**Nakamichi**

Model Cassette Decks (See MODEL below.)  
 Serial No. from -  
 Subject Countermeasure for Breakage of Eject Linkage Holder in Mechanism Ass'y

No. OOD-SI-3115 (1/2)  
 Date 10 November 1988

Fig. 1

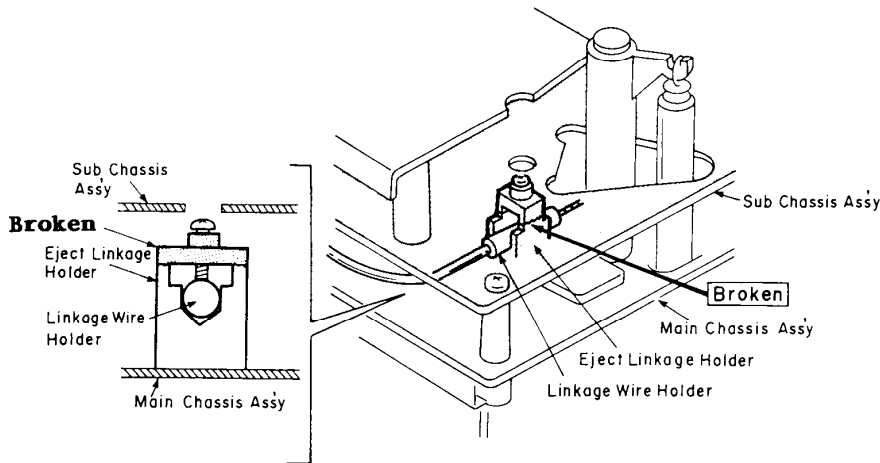
This Service Information is prepared to give information how to repair when molded upper part of the Eject Linkage Holder is broken as shown in Fig. 1. As the Eject Linkage Holder fixes the Linkage Wire Holder, breakage of that part causes eject operation of the cassette compartment to be inoperative.

- (1) Remove the Mechanism Ass'y.
- (2) Remove the broken part of the Eject Linkage Holder (shaded part on the left side of Fig. 1).

Fig. 2

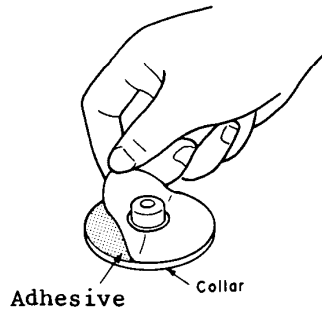
- (3) Stick the Adhesive Tape to the Collar and peel of the paper as shown in Fig. 2.
- (4) Mount the Collar and stick it firmly. See Fig. 3.

Fig. 4

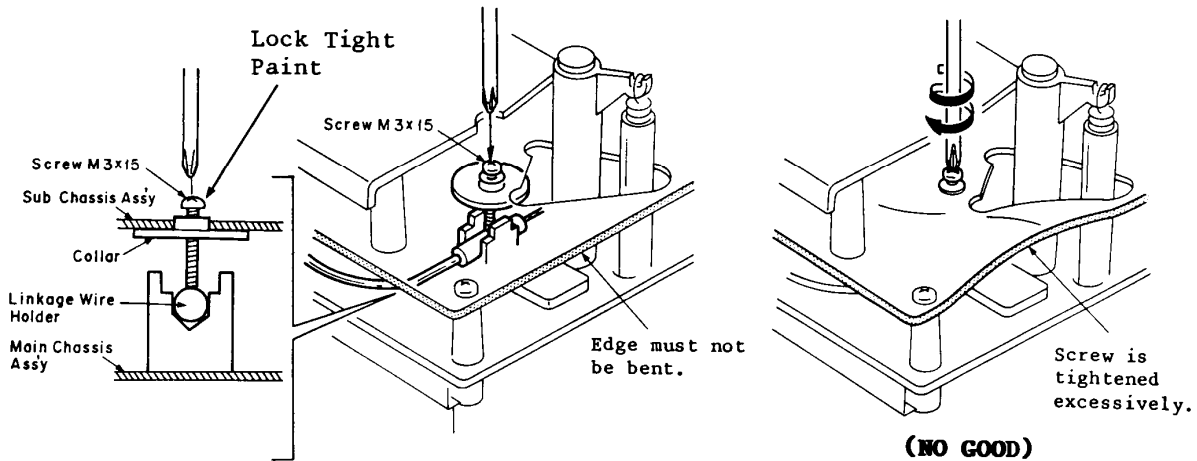
- (5) Install a screw M3x15 and fix the Linkage Wire Holder by tightening it. Excessive tightening causes the Sub Chassis Ass'y to be bent. So, look at the edge of the Sub Chassis Ass'y and make sure that it is not bent. See Fig. 4.
- (6) After fastening the screw M3x15, apply a quantity of lock tight paint to the screw.
